3. DYNAMIC LOAD ANALYSIS FOR NEW FUEL RACKS IN THE BUFFER POOL

The purpose of this section is to present the structural analysis of New Fuel Storage Racks (FSR) for the Buffer Pool located in the Reactor Building (RB) of the ESBWR.

Figure 5-1. SFP Model

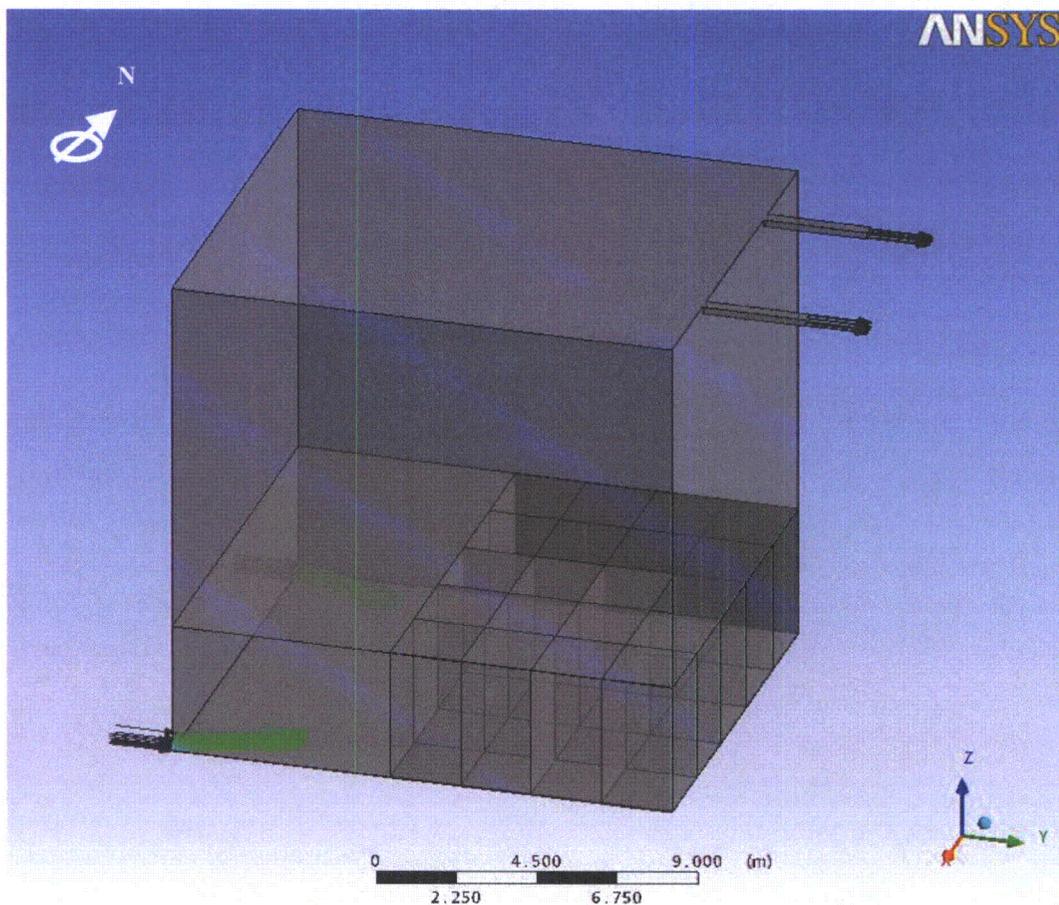
Using NEDO-33373, Figure 5-1, the staff estimated the depth of the pool as 12.5 meters. Assuming that the top of the heated fuel is 3.5 meters from the bottom of the pool, the depth of the highest part of a fuel rod is 9 meters. For water that is 60 degrees C (140 degrees F), the density is 983 kilograms per cubic meter (kg/m^3) (from the ASME Steam Tables, Ref. 34) and the pressure at the 9-meter depth is 1 atmosphere + (density) x (acceleration due to gravity) x (depth) ($P = 101,325 \text{ pascals (Pa)} + 983 \text{ kg/m}^3 * 9.8 \text{ meters per second squared (m/s}^2) * 9 \text{ meters} = 188,026 \text{ Pa}$) or 1.86 atmospheres. The saturation temperature at this pressure (interpolated from the ASME Steam Tables, Ref. 34) is 117.8 degrees C (244 degrees F). This indicates that boiling could occur for temperatures below the 121 degrees C (250 degrees F) criterion set by the applicant.

Figure H5-2. Loss coefficient in Racks

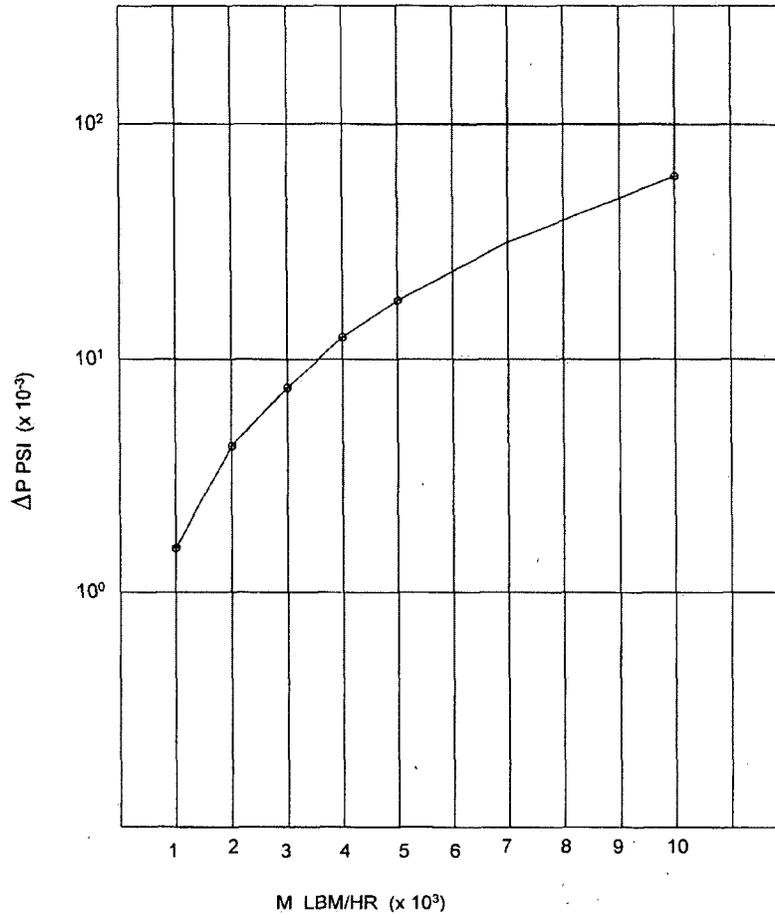
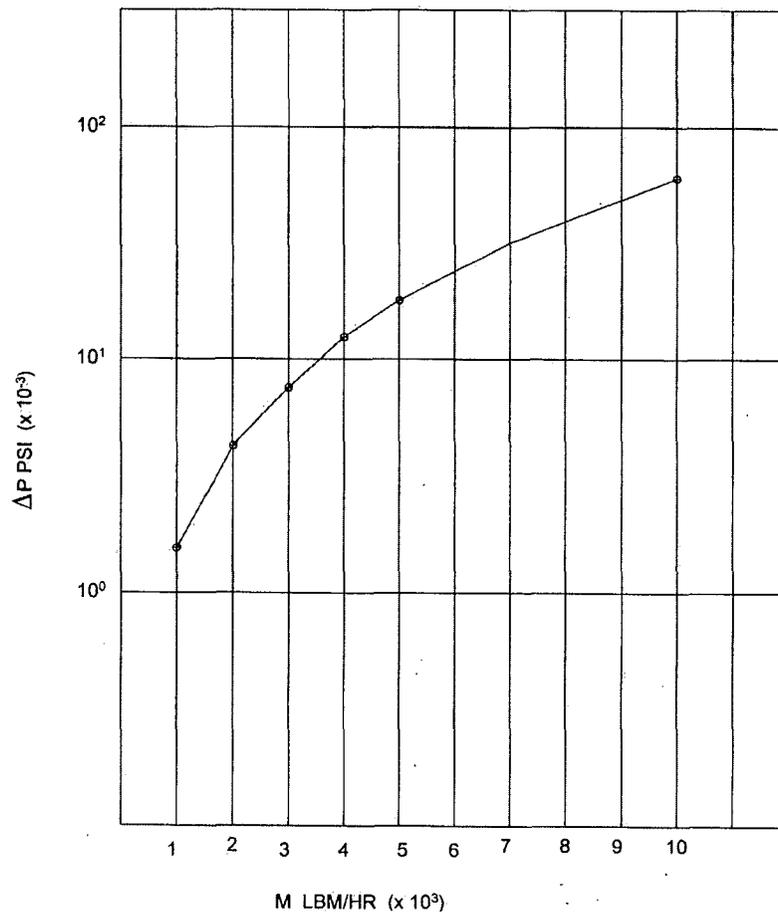
NEDO-33373, Section 5.2 and Appendix H describe the empirical basis for the loss coefficients in the CFD model and their representation in NEDO-33373, Figure 5.2 (repeated in Figure H5-

2). In RAI 9.1-126 (Ref. 34), the staff asked the applicant to clarify NEDC-33373P, Revision 1, Figure 5.2, which is the plot of loss coefficient in the racks and presents the pressure drop as a function of mass flow. In its response dated July 31, 2009 (Ref. 41), the applicant explained that these data are calculated and that the mass flow refers to a single bundle. The applicant also explained that the pressure drop was bounding, because it was based on fuel for existing reactors rather than the shorter ESBWR fuel. The staff concludes that the response is acceptable because the response clarified the information in NEDO-33373, Figure 5.2, and how it is used in the cooling analysis. Therefore, the staff finds the loss coefficient of the CFD model to be acceptable. On the basis of the applicant's response and NEDO-33373 revisions, RAI 9.1-126 is resolved.

Figure 5-12a. Stream Lines From Inlet #1 Through Rack #5

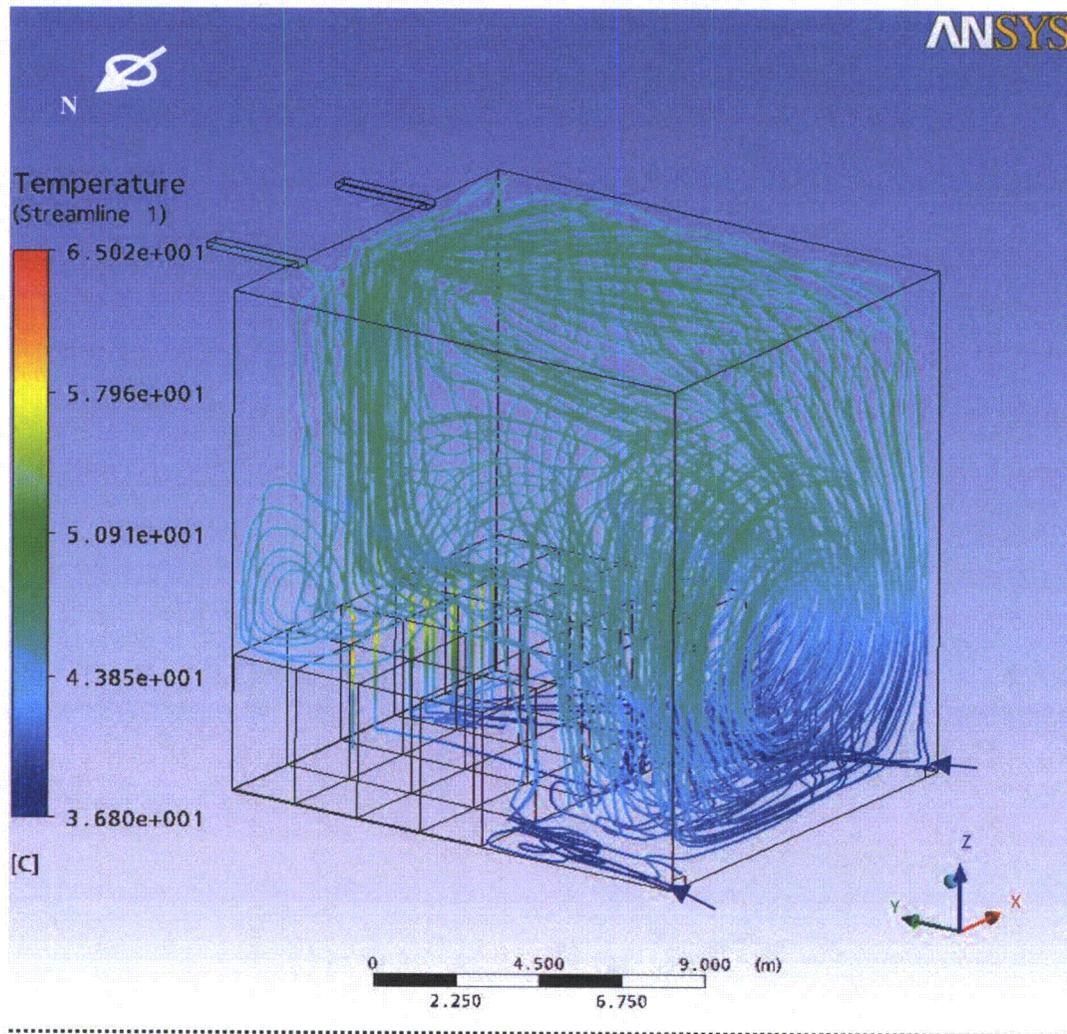
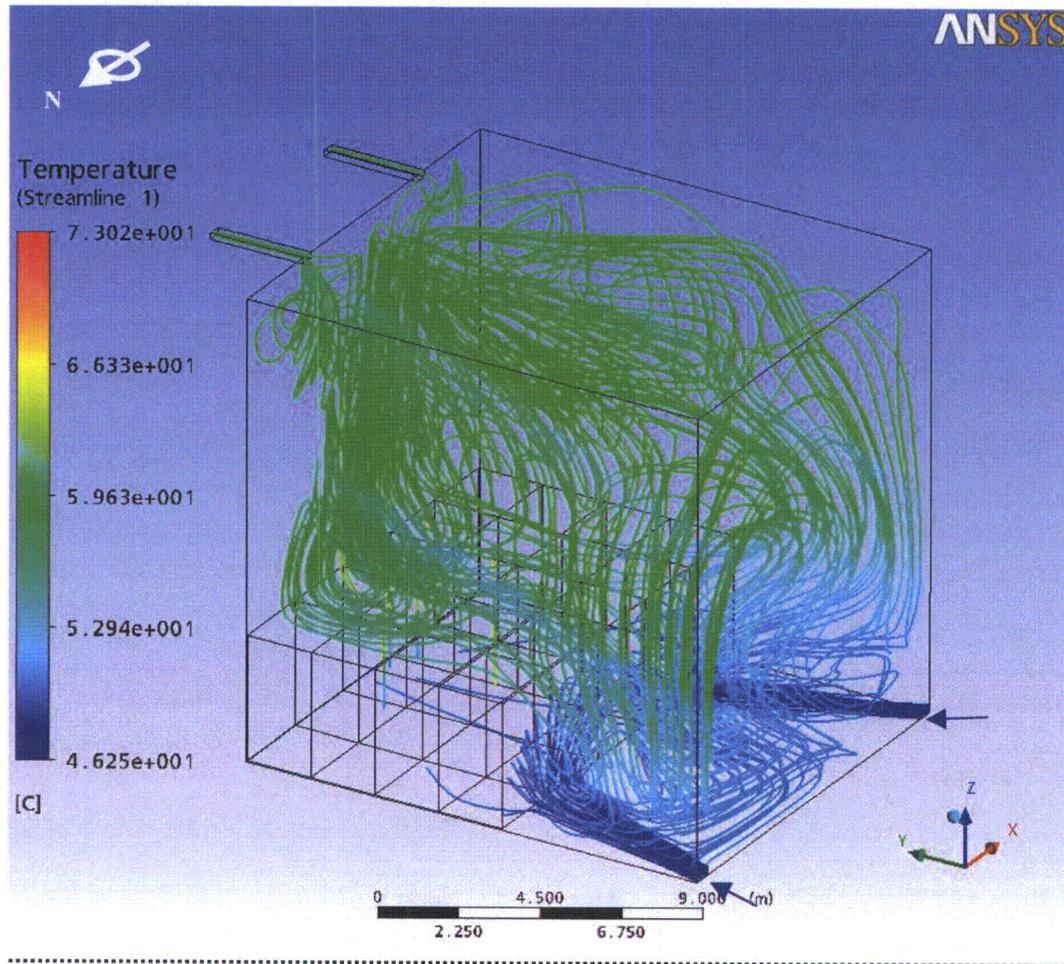
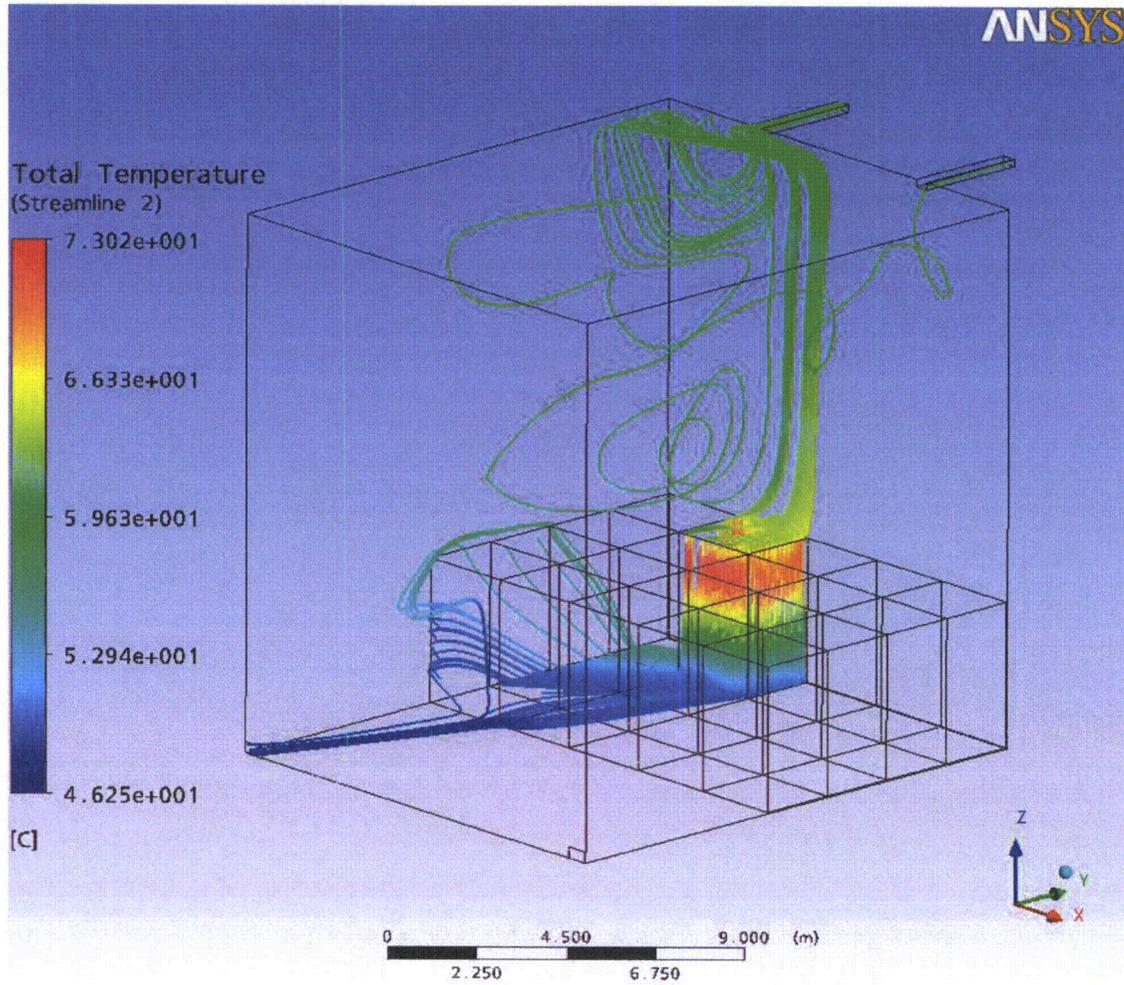
The staff assessed the CFD results for demonstration of natural circulation through the storage racks. In NEDO-33373, Figures 5-9, 5-12, and 5-12a show streamlines from inlets to outlets under normal and abnormal conditions, respectively. The figures show that the pools are well mixed and provide evidence of flow through the racks. This supports the conclusion that there is natural circulation through the racks; therefore, the staff finds that the natural circulation criterion is met.
